Three Mile Island, Unit 1 (TMI Unit 1)  
Facility Operating License No. DPR-50  
NRC Docket No. 50-289

**Subject:** Response To Request For Additional Information – Technical Specification Change Request No. 335: Reactor Coolant System Pressure-Temperature Safety Limit (TAC No. MD4910)

**RESPONSE TO REQUEST FOR ADDITIONAL INFORMATION  
TECHNICAL SPECIFICATION CHANGE REQUEST No. 335  
Reactor Coolant System Pressure-Temperature Safety Limit**

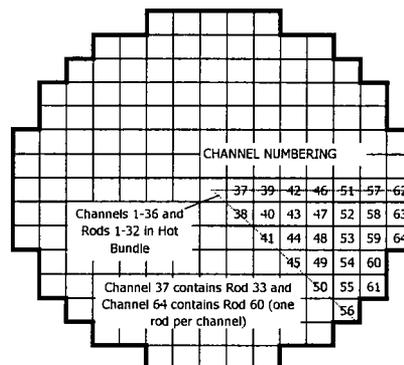
First, it might be beneficial to explain the LYNXT model with a full core of Mark-B-HTP fuel. For TMI Cycle 17, the core is modeled as 177 Mark-B-HTP fuel assemblies (using a 1/8 core symmetry model with LYNXT) as shown in Figure 1. This model is composed of 12 channels. The limiting, or hot, bundle is modeled at the core center.

Channels 1 through 10 represent individual subchannels. Channel 11 represents the remainder of the hot bundle. Channel 12 represents the remainder of the core. The limiting location for the placement of the hot pin is Rod 6 for the BHTP correlation (Reference 2). The limiting fuel rod is modeled as a  $1.800 F_{\Delta H}$  with a 1.65 symmetric axial power shape.

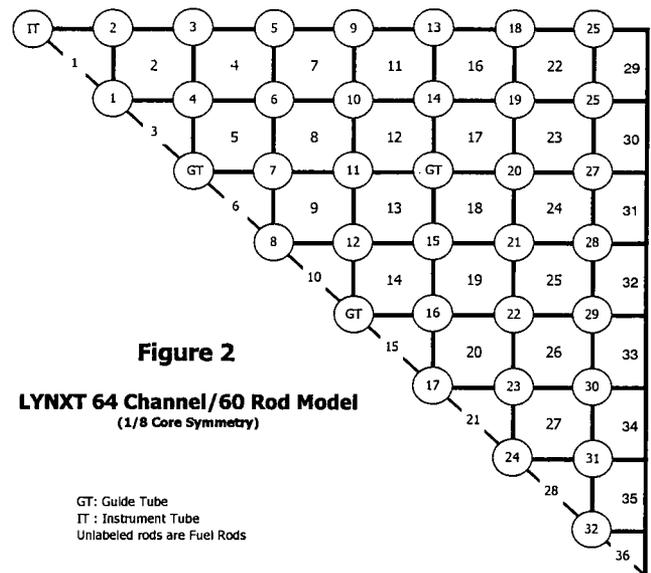
The LYNXT model for the transition core is composed of 64 channels and 60 rods as shown in Figure 2. Again, the limiting fuel rod is modeled as a  $1.800 F_{\Delta H}$  with a 1.65 symmetric axial power shape at Rod 6 when the hot bundle is modeled as a Mark-B-HTP fuel assembly and the DNB performance is predicted using the BHTP correlation. For cases where the hot bundle is modeled as a Mark-B12 fuel assembly, the limiting fuel rod,  $1.800 F_{\Delta H}$  with a 1.65 symmetric axial power shape, is placed at Rod 2 for DNB predictions using the BWC CHF correlation (Reference 3). AREVA has determined the limiting hot rod location for the respective CHF correlations by moving the hot rod throughout the hot bundle to isolate the most severe DNB response. This action assures the most conservative DNB prediction for the design power distribution ( $1.800 F_{\Delta H}$  with a 1.65 symmetric axial power shape at the hot rod) for each fuel design.

**Figure 3**  
**Transition Core Configuration for Mark-B-HTP**  
**Hot Bundle with 85 Mark-B-HTP Fuel Assemblies**  
**in the Core**

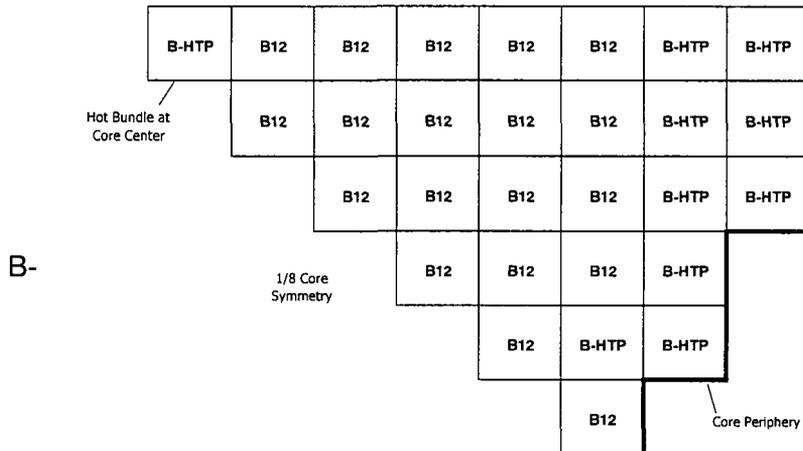
Figure 3 shows the core Configuration1 that accentuates the flow diversion out of the Mark-HTP hot bundle in the transition cycle assuming there are 65 Mark-B-HTP fuel assemblies in the core. (This assessment was actually performed for different numbers of Mark-

B-HTP fuel assemblies in the core. However, the details being described here are for the case with 65 Mark-B-HTP fuel assemblies in the core.) By conservatively placing all the lower pressure drop Mark-B12 fuel around the limiting Mark-B-HTP hot bundle, the most conservative DNB penalty can be determined for a limiting Mark-B-HTP fuel assembly.

The transition core DNB penalty associated with the Mark-B-HTP hot bundle was computed by determining the difference between the DNB performance of the transition core, represented in Figure 3, and the DNB performance obtained using a full core model of Mark-B-HTP fuel assemblies. Both LYNXT models used the 64 channel/60 rod LYNXT model as shown in Figure 2.

**Figure 5**  
**Conservative Transition Core Configuration for Mark-B Hot Bundle**  
 (Number of Mark-B-HTP Modeled is less than Actual number in Core)

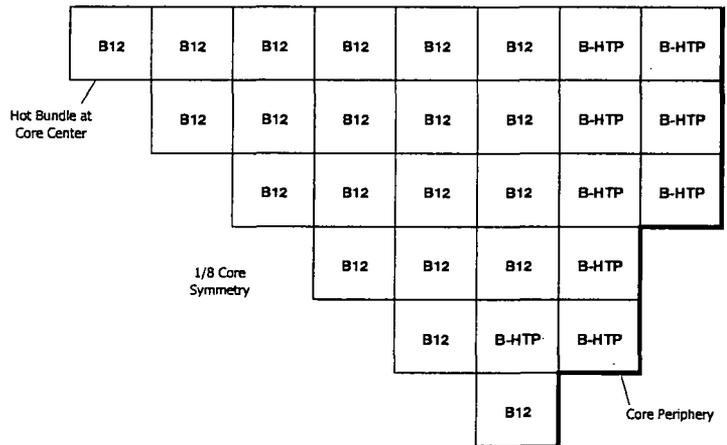
This same procedure is performed for the core Configuration 2 where the hot bundle is the resident fuel design, or Mark-B12. In Figure 5 one can see the placement of the Mark-B12 fuel design into the hot bundle location. In order to maximize the diversion of flow out of the Mark-B12 hot bundle the hot bundle is surrounded with other Mark-B12 fuel assemblies (having a lower pressure drop than the Mark-B-HTP fuel). The placement of Mark-B-HTP fuel adjacent to or near the Mark-B hot bundle would reduce the amount of coolant being diverted from the Mark-B12 hot bundle.

The transition core DNB penalty associated with the Mark-B12 hot bundle was computed by determining the difference between the DNB performance of the transition core, represented in Figure 5, and the DNB performance obtained using a full core model of Mark-B12 fuel assemblies. Both LYNXT models used the 64 channel/60 rod LYNXT model as shown in Figure 2.

Proposed Variable Low Pressure Trip (VLPT) Setpoints and Calibration Criteria

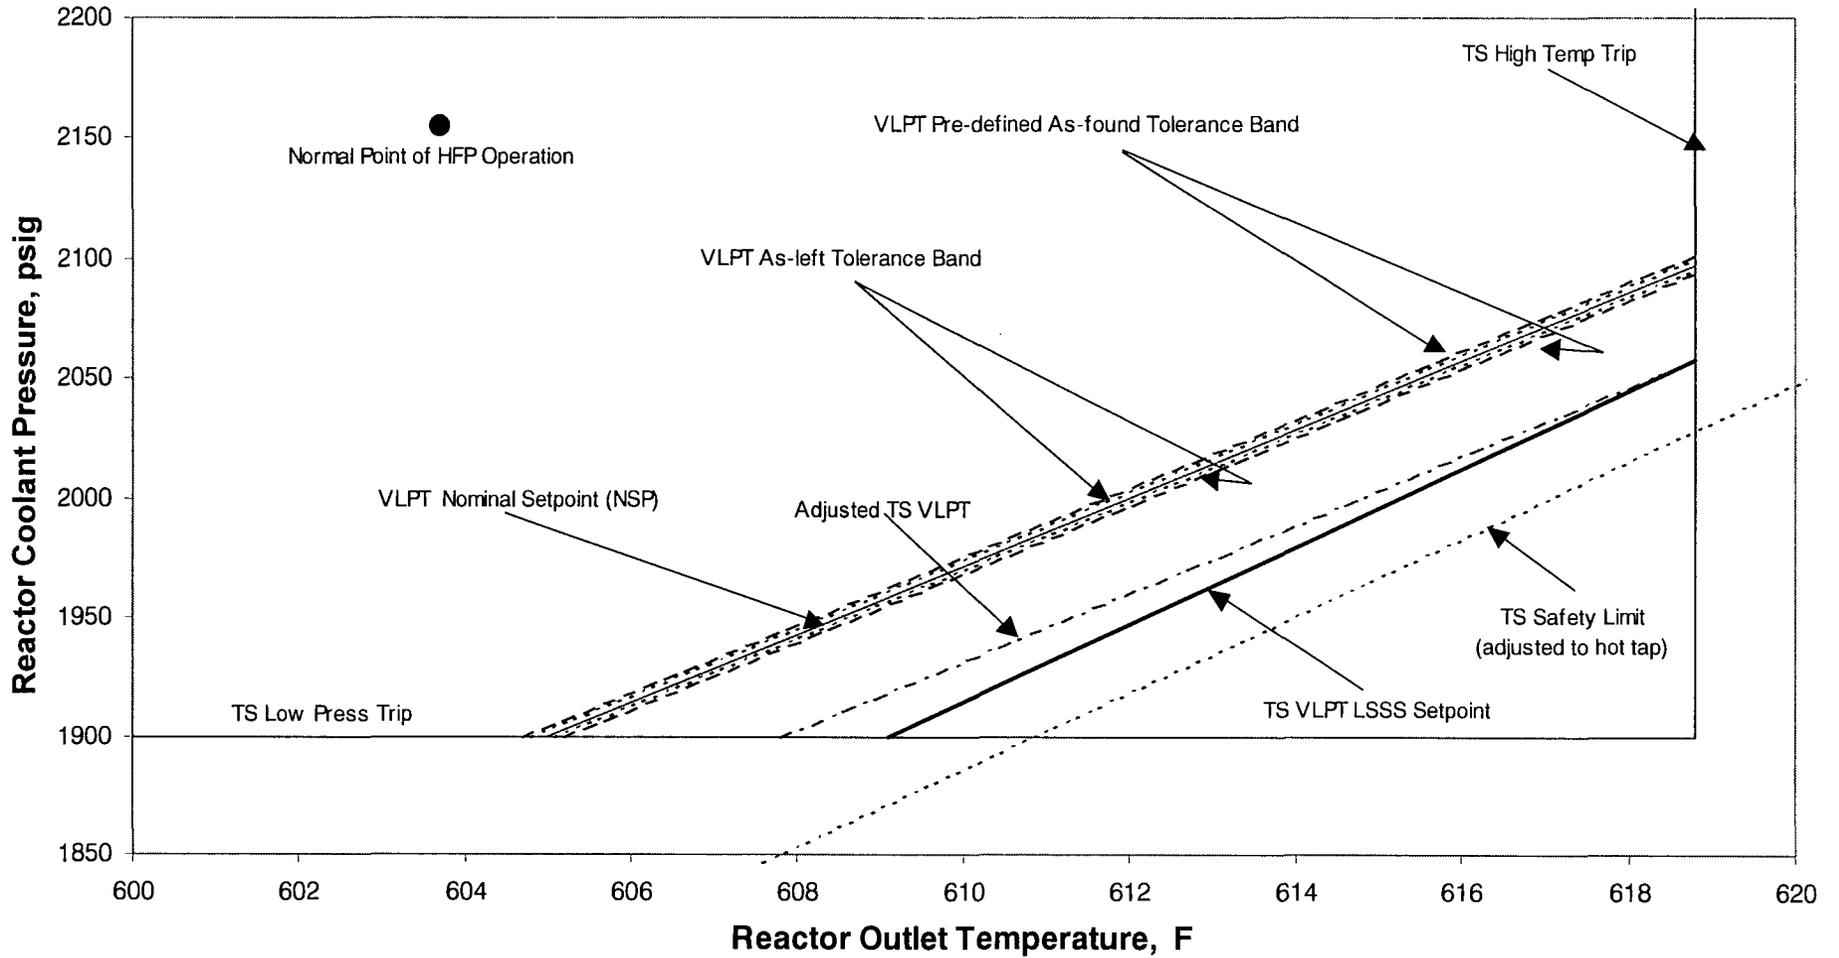
Demonstrate that, for operation with measured values at the limits of the "Acceptable Operation" region of proposed TS Figure 2.3-1, there would be adequate assurance that the actual operating point will be conservative relative to the indicated Safety Limit line, given measurement errors consistent with the instrument channel uncertainties.

Identify the low reactor coolant pressure and high reactor outlet temperature intercept points for:

Therefore, the TLU is applied a second time in determining the Total Margin so that the NSP protects the AV in the same manner that the AV protects the Analytical Limit. The surveillance test procedure NSP as-left tolerance is included in the Total Margin because it is not included in the TLU calculation. The additional discretionary margin provides additional conservatism. The NSP does not significantly impact the normal plant operating region. See Attachments 1 and 2 for graphical illustration.

Note 1: The VLPT As-Left tolerance is  $\pm 2.16$  psig. The As-Found tolerance is  $\pm 3.52$  psig. See Attachments 1 and 2 for graphical illustration.
